Modification of Minister's Approval

Section 75W of the *Environmental Planning & Assessment Act 1979*

Application Number:	MP09_0165
Proponent:	Urbis Pty Ltd
The Authority:	Minister for Planning
The Land:	Lot 6 DP 260000, Lot 3 DP 25688 & Lot 4 DP25688 5 Whiteside Street and 14 and 16 David Avenue, North Ryde
Concept Approval:	Residential flat development concept granted on 10 September 2013 by the Planning Assessment Commission
Modification:	MP 10_0165 MOD 1: the modification includes: <ul style="list-style-type: none">• increase the total number of dwellings from 135 to 165 units (an additional 29 units);• amendment of building envelopes A, B, D and basement car parking building envelope;• amend vehicular access arrangements and inclusion of car parking rates; and• amendment of balcony requirements for Building B.

The Concept Plan for MP10_0165 is modified as follows:

~~Figure 1: Revised Building Envelope - Building A~~

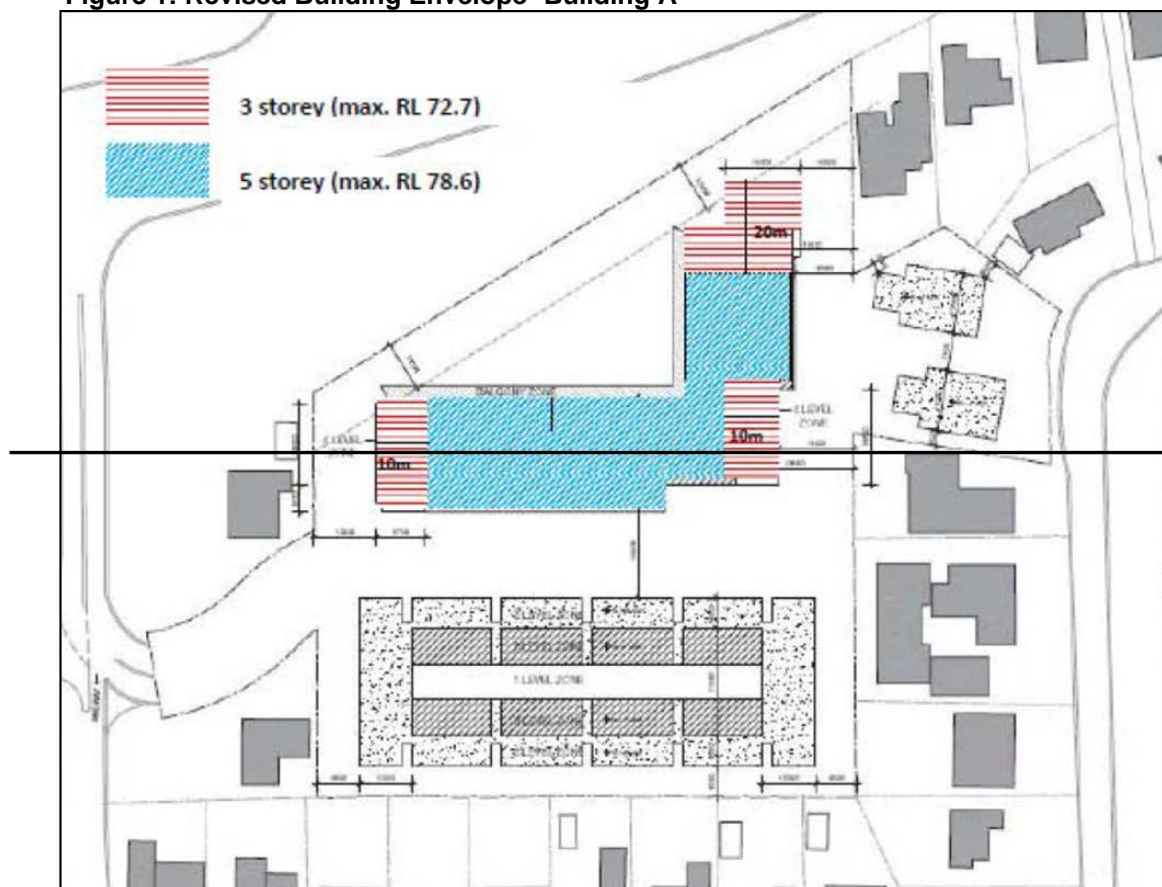
- (f) Schedule 2 Part B - Modification B1 is deleted by the ~~bold struck out~~ words/numbers as follows:

~~B1 BUILDING ENVELOPE HEIGHT MODIFICATIONS~~

~~The building heights shown on 'Envelope Plan' DA-04 prepared by SJB Architects and referred to in condition A2 shall be modified as follows:~~

- a) ~~the building envelope for Building A (fronting Epping Road) shall be reduced to 3 and 5 storeys (maximum RLs 72.2, and 78.6, respectively) as illustrated in Figure 1 below, excluding any plant, lift overruns, or similar projections). Drawings indicating heights to AHD shall be provided with the future application/s.~~
